Architectural Commission Report

Meeting Date: Wednesday, March 19, 2014
(Continued from the Architectural Commission meeting on January 15, 2014)

Subject: **457-461 & 449-455 NORTH CANON DRIVE**
Request for approval of a façade remodel and business identification signage. The Commission will also consider adoption of a Categorical Exemption, pursuant to the California Environmental Quality Act.
(PL1333361 & PL1403223)

Re-Finish Facade & Elevation Plan

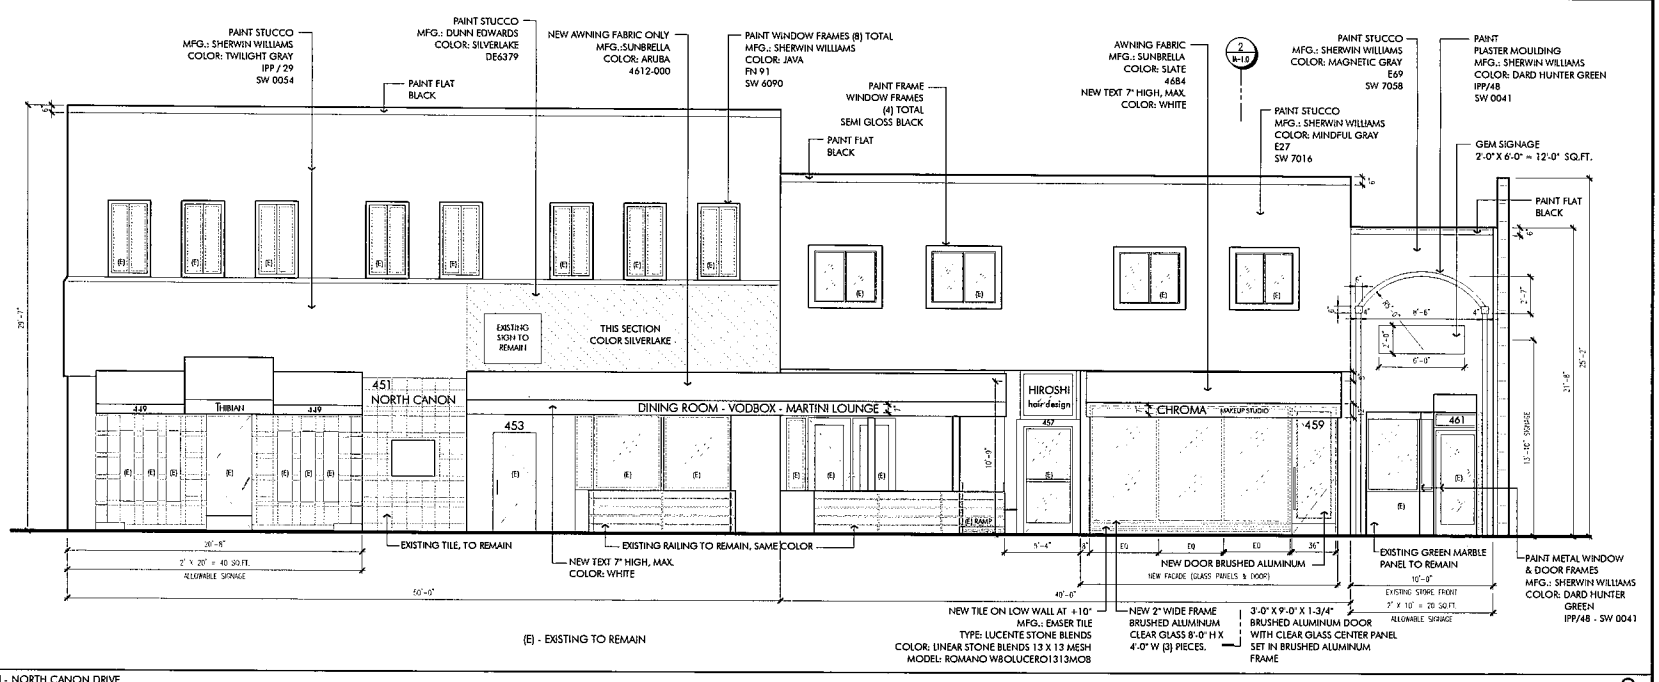
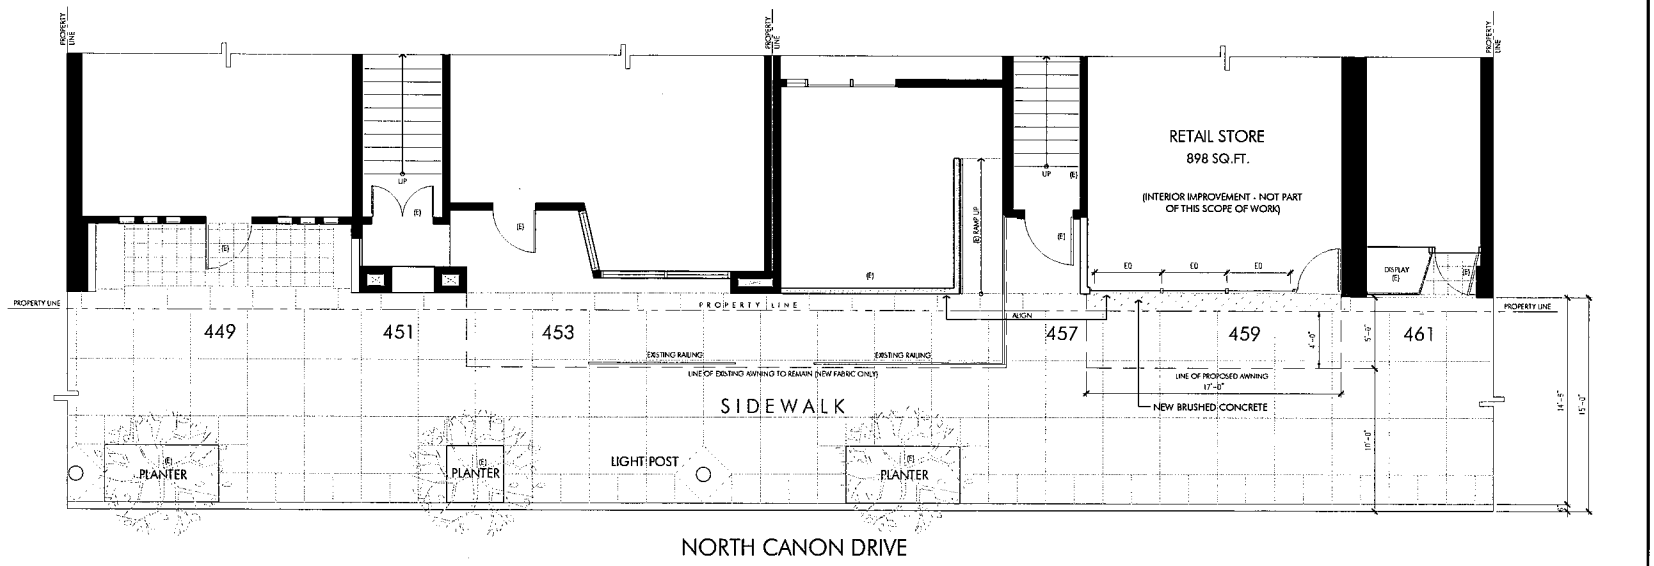
- While the recovering of the awning is a positive enhancement, the existing configuration of the awning at Nic's does not appropriately draw attention to or enhance the entrance. The applicant should consider utilizing a configuration similar to that currently existing at Thibiant in order to use the awning as an architectural element and bring attention to the entrance. Additionally, the text on the awning does not appear to be centered when viewed in a horizontal plane and it should be centered on the awning valence.

- The Gem Mountain Studios awning should have a canopy that differentiates the storefront from the two larger buildings. The applicant should consider using a canopy consisting of glass and steel.

- The proposed façade plaster molding on Gem Mountain Studios should be removed as it presents a false historicism and is not consistent with the Secretary of the Interior Standards.

Re-Finish Facade & Elevation Plan

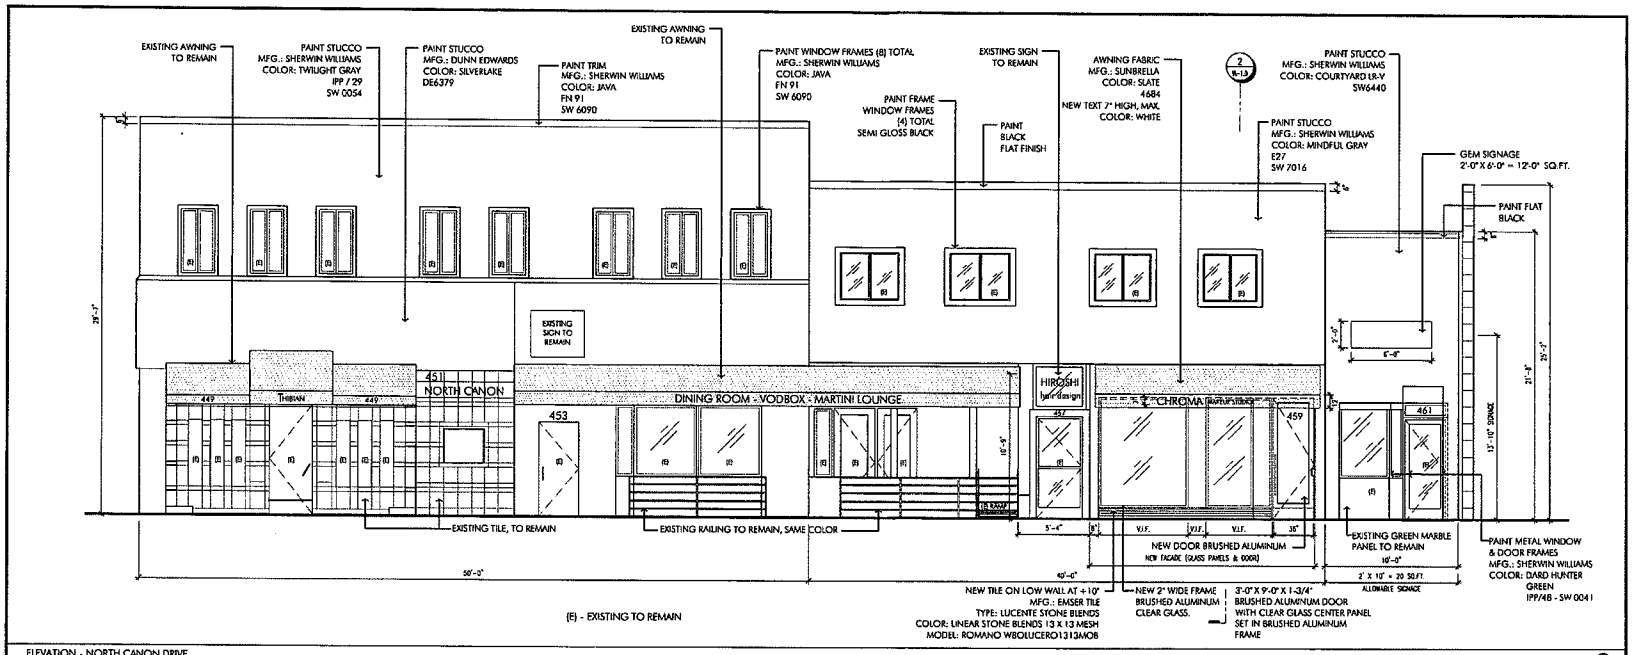
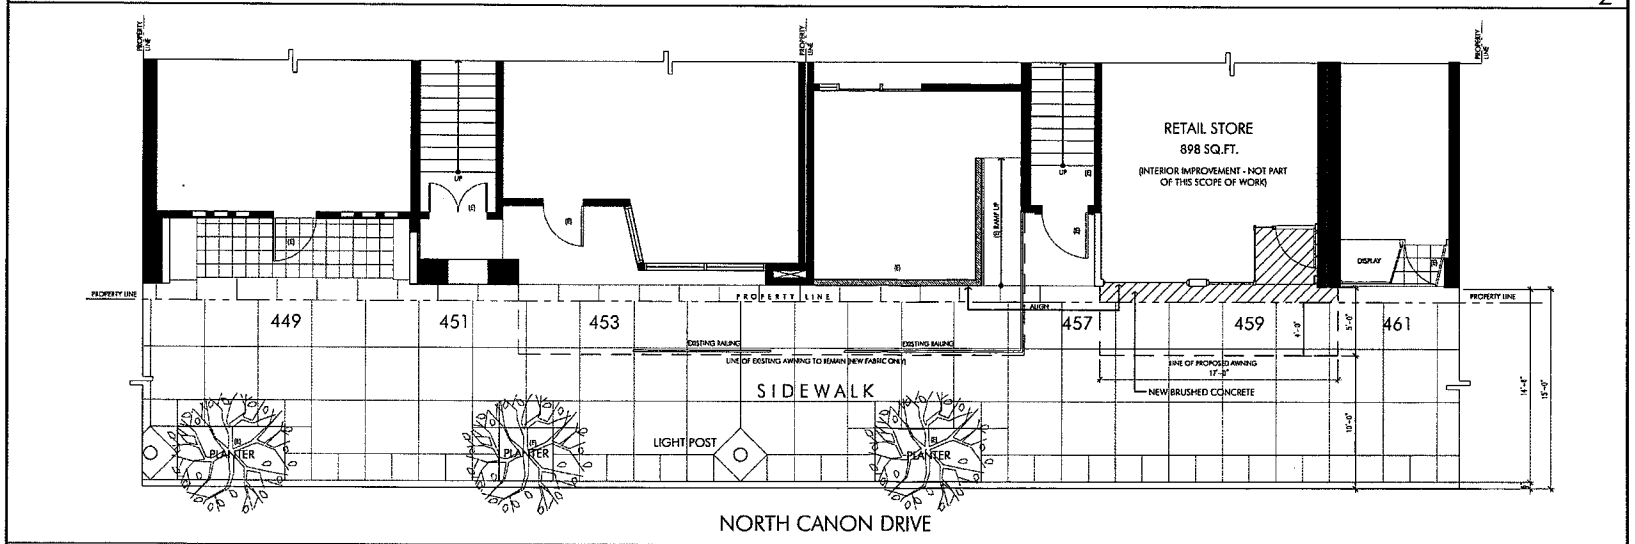
The applicant has thoughtfully incorporated the Commission's comments to create a more cohesive aesthetic for the two properties. However, the Urban Design staff has identified changes that may be made to further enhance the streetscape:

- Utilize a lighter shade for the Gem Mountain Studios façade as the proposed color creates an overly dark storefront. Additionally, the proposed color does not provide a substantial contrast from the parapet cap.
- For the building located at 457-461 North Canon Drive, differentiated paint colors or shades should be utilized on the second story façade above each ground floor storefront (Chroma Hair Studio and Nic's) to break up the horizontal massing at the second floor. Additionally, by mimicking the ground floor storefront widths on the second floor through such differentiation, a more appropriate streetscape rhythm will create a more village-like feel on North Canon Drive.

1. 449,451 & 453 Building
   Angled portion of the façade above both existing awnings, one paint color, uniform color element.

2. 449, 451 & 453 Building
   Upper section of building one uniform paint color.
   Window frames and parapet top cap – same color, identifying building element.

3. 457 & 459 Building
   Upper section of building one paint color, separating from adjacent building.
   2nd floor window frames and parapet top cap same color – black, identifying building elements.

4. 461 Building
   Separate paint color – façade.
   Separate darker color for window/door frame and parapet top cap, unifying smaller building.

5. Existing awnings to remain:
   449 – Thibian
   453 – Nic's Restaurant
   459 – New awning previously approved resolution no. AC 05-14

Page: 1 Elevation
Sign detail Halo illum.

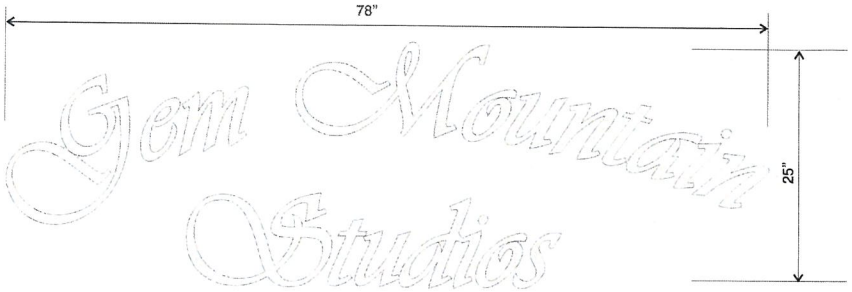
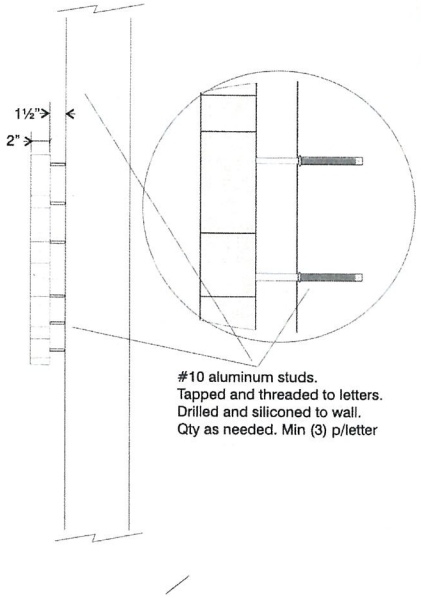
Pursuant to Beverly Hills Municipal Code §10-4-604, the maximum sign area for ground floor tenants is two (2) square feet in area for each one foot (1') of ground floor street frontage that such business occupies within the building. Based on a linear storefront of 17"-0", the maximum sign area for this

tenant is 34 SF. Additionally, ground floor tenants may have an additional 5 SF business identification sign. As such, the proposed business identification signage is within the maximum standards set forth in the BHMC.

Halo illuminated pan channel letters
Letters painted light contrasting color TBD
White LED illumination.
